Meeting Agenda

Work Session

Tuesday, April 11, 2017

4. [17-0205](#) PUBLIC HEARING: Consideration of Resolution 2017-14, To Be Entitled: "A Resolution Approving A Revised Development Plan For Harpeth Square PUD Subdivision, With 5 Existing Modifications Of Development Standards For The Property Located Within The Block Of 1st Avenue, Bridge Street, 2nd Avenue North And East Main Street."; (3/23/17 FMPC 6-0, 04/11/17 WS)

HarpSq DevelpPlan Rev2_.pdf

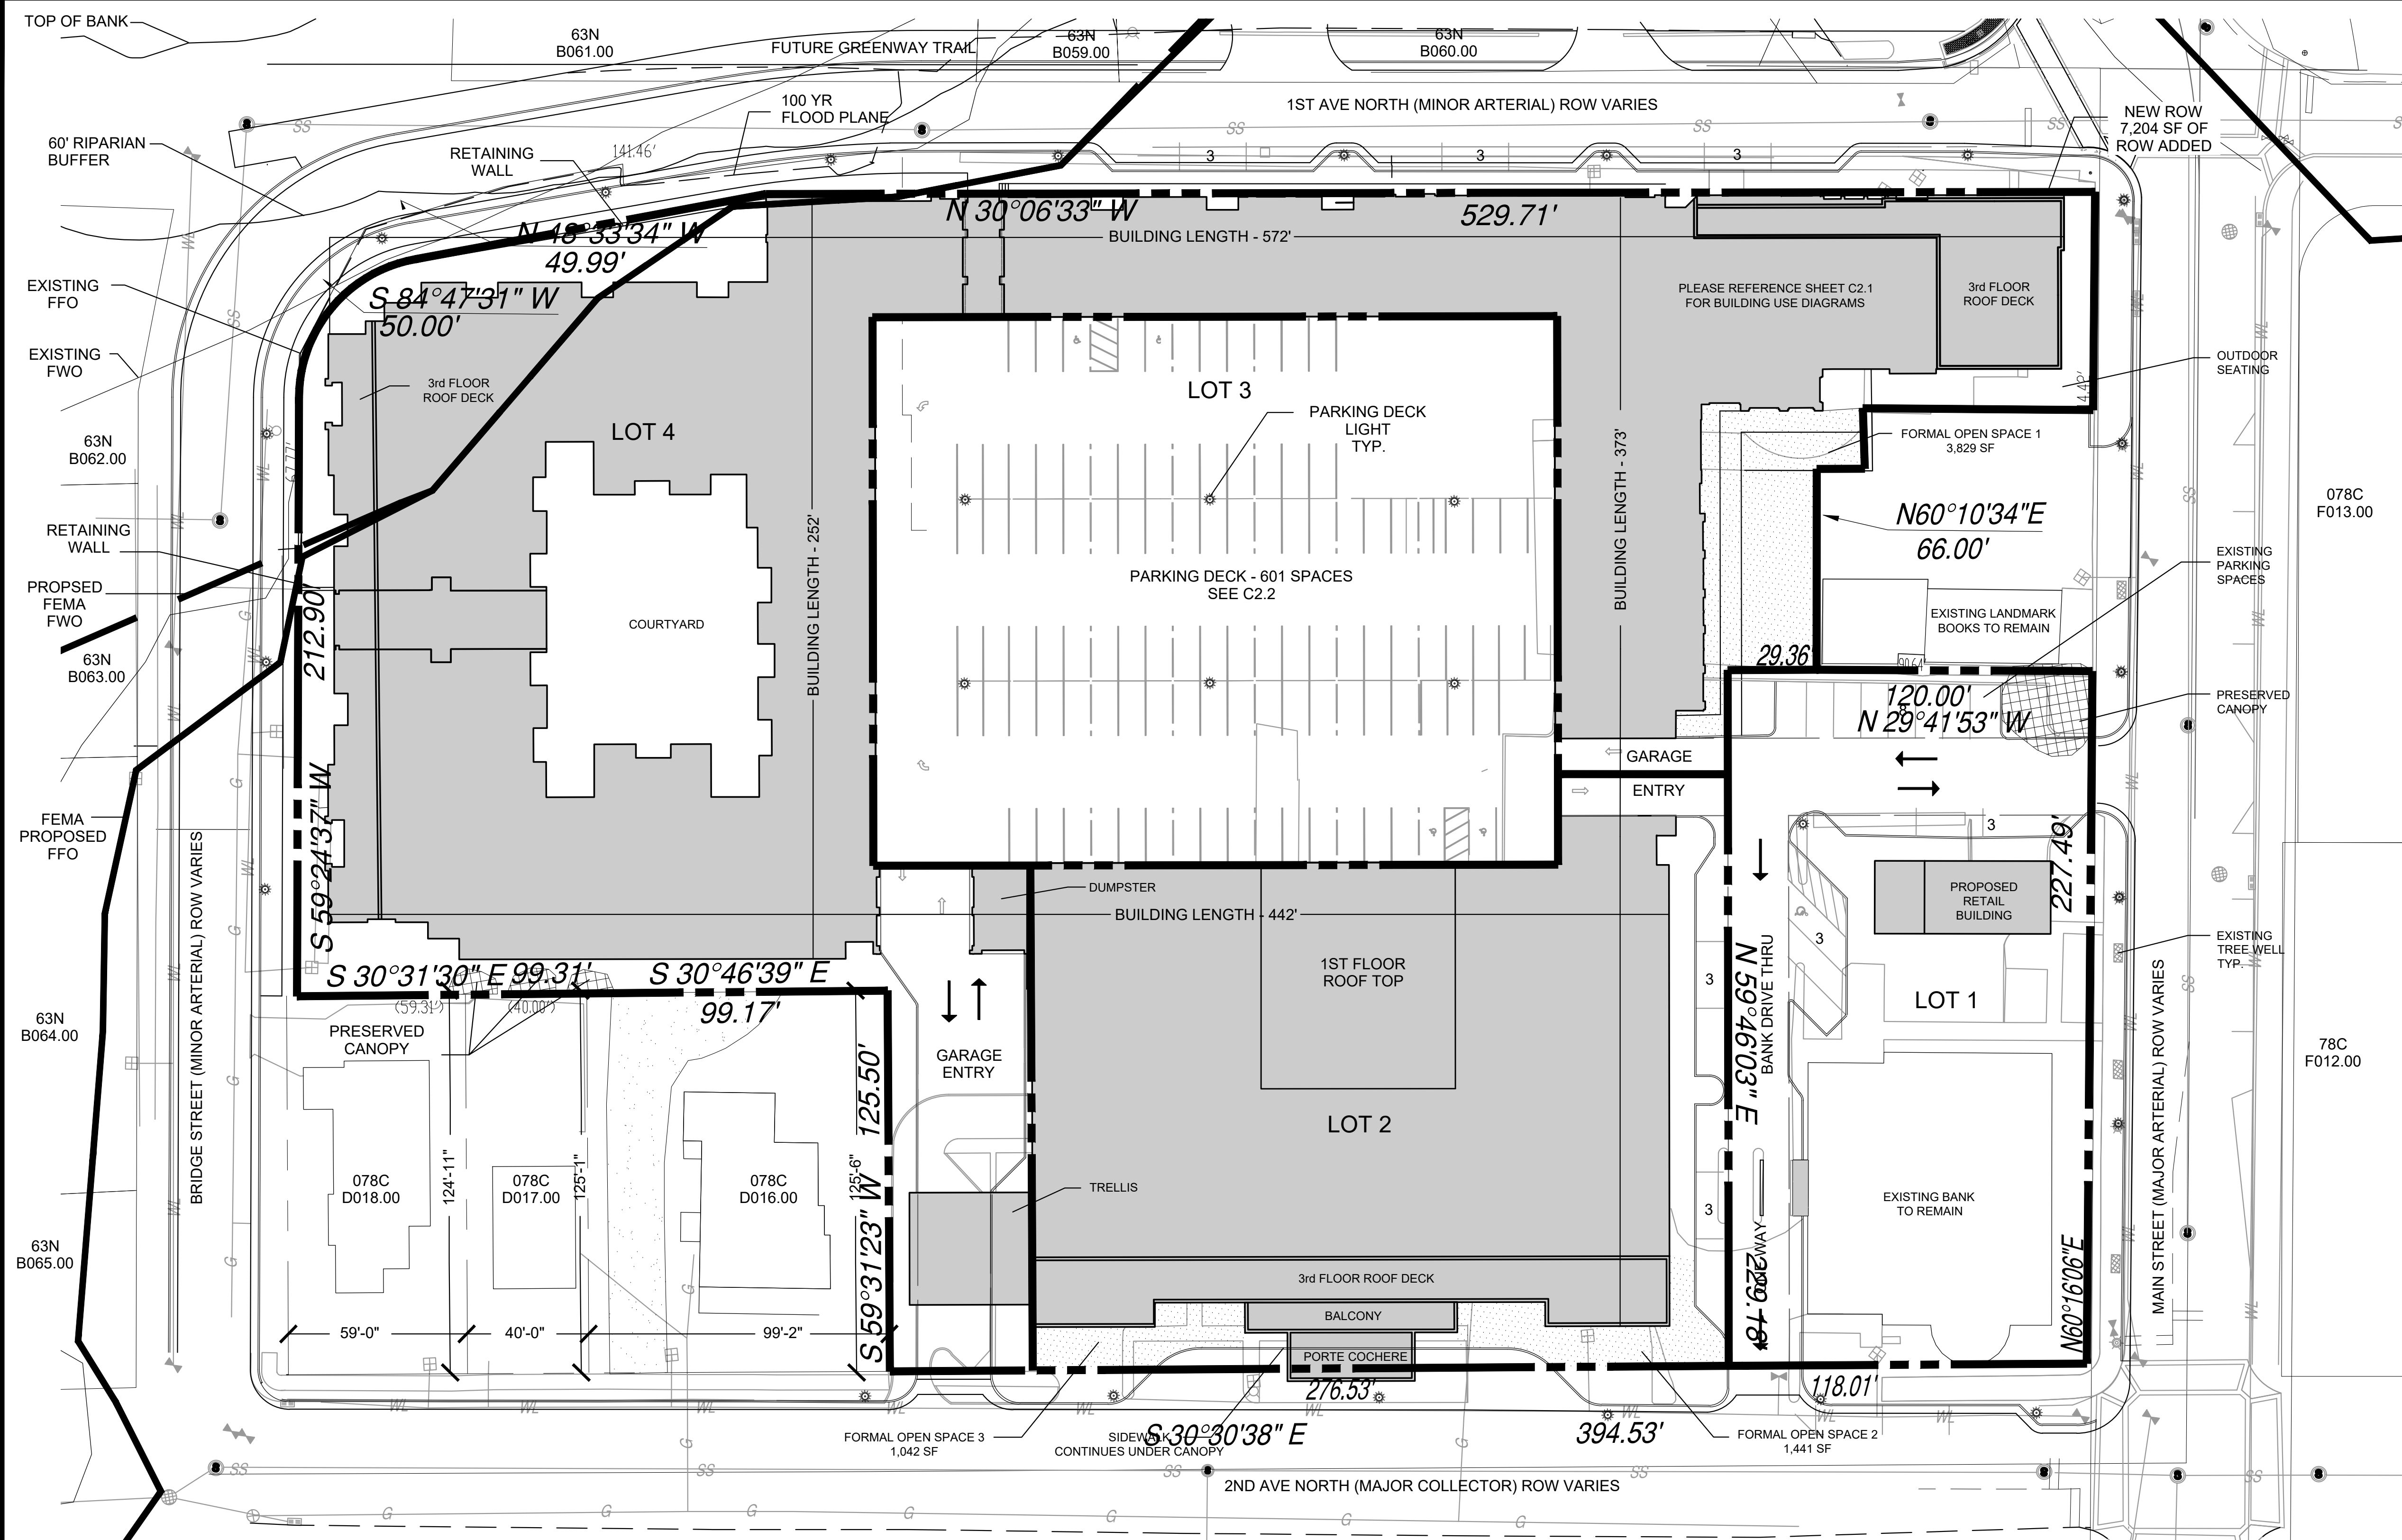
Existing zoning taken from Ordinance 2015-74. Stated zoning is an incorrect combination of Ordinance 2014-41 and the proposed number of hotel rooms.

Update EVERY sheet with the correct proposed zoning, including the Landscape Plan and Elevation sheets where the proposed zoning is listed.

The site data charts have been updated with the correct existing and proposed zoning.
